Re: Campus Security Camera Replacement RFP No 23-24-01 Addendum #2

IMPERIAL VALLEY COLLEGE Campus Security Camera Replacement

ADDENDUM#2

24" X 36" PULLBOX

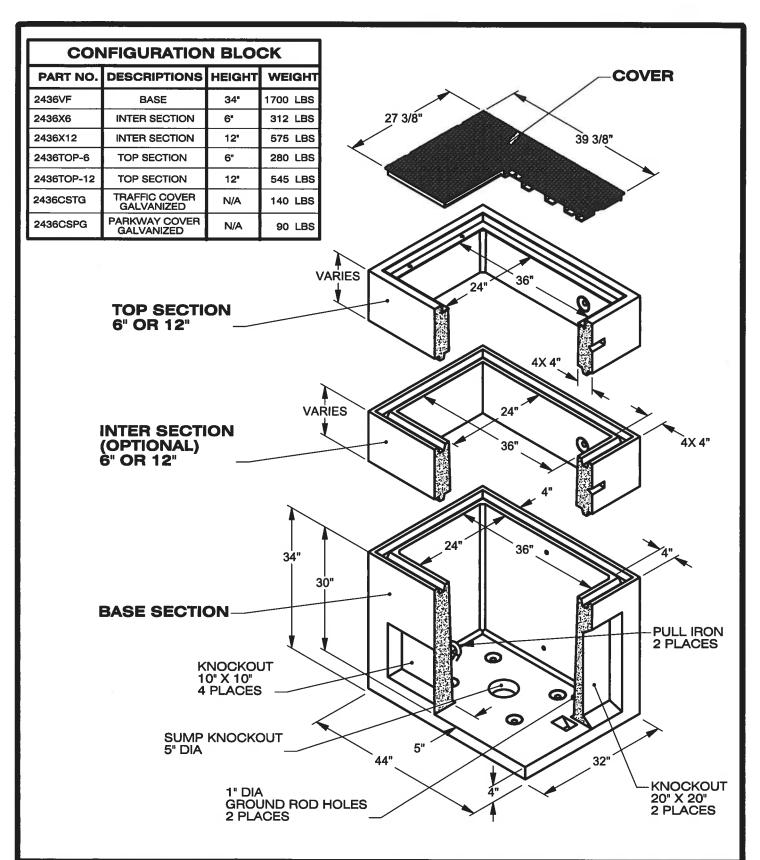
2. **Question:** Please indicate pull box size required through out the project. No sizes are noted.

1. Provide US Concrete Precast Group 24" x36" pull boxes shown in plans.

Answer: Provide us concrete precast group 24"x36" pullbox 2436VF.
